Reference : DA 19/0649 File No : D/2019/0649

RE: DA 19/0649 52 Plumpton Road Tatton, Lot 336 DP 1247818 – Matt Jenkins

Your Reference: Concept development application to subdivide land into 37 residential lots

Application No: DA 19/0649

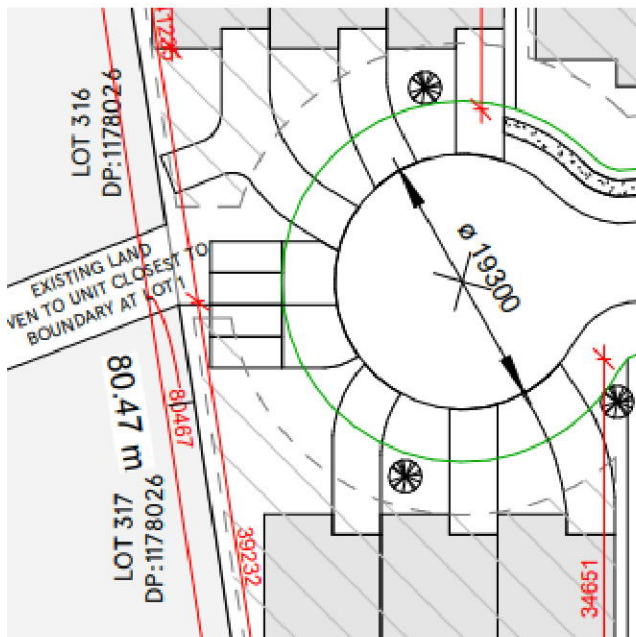
We have received the letter from Council regarding DA19/0649 and have viewed the corresponding plans. [REDACTED] we are really concerned as the DA plans show encroachment [REDACTED]

Please see attached excerpt from the submitted plans – can this be reviewed?
